## **Engine - MIL ON/DTC's P2000-P2008/P2015/P2020 Set**

TSB 06-7-10

MIL ON WITH DTC P2004 THROUGH P2008, P151A,  
P2015, P2020 - 4.6L 3V

This article supersedes TSB 05-25-15 to update the vehicle model years.

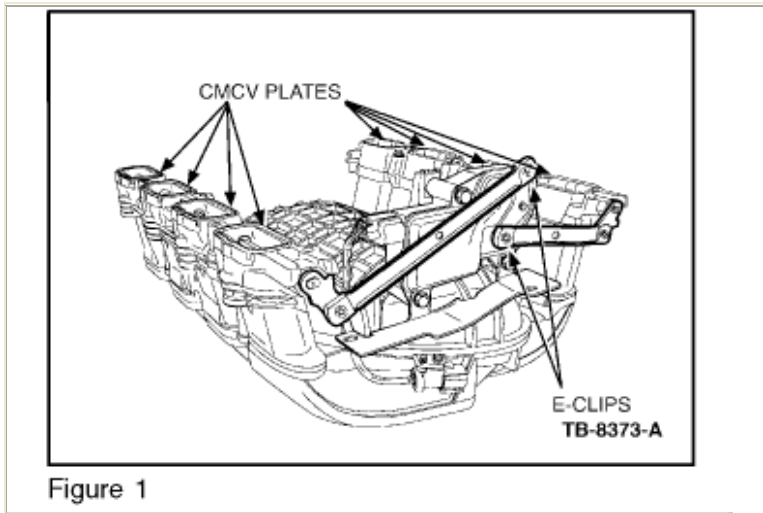
3. Disconnect the CMCV linkages from actuator motor by removing the two (2) clips (Figure 1). Discard clips.
4. Rotate each CMCV shaft (right hand and left hand) by hand, to verify that the system does not stick or bind. The shafts should rotate freely and any sticking or binding will require replacement of the entire [intake manifold](#).
5. If the components inspected in Steps 1, 2, and 3 are OK, then replace CMCV actuator motor by following procedure included in the service kit.
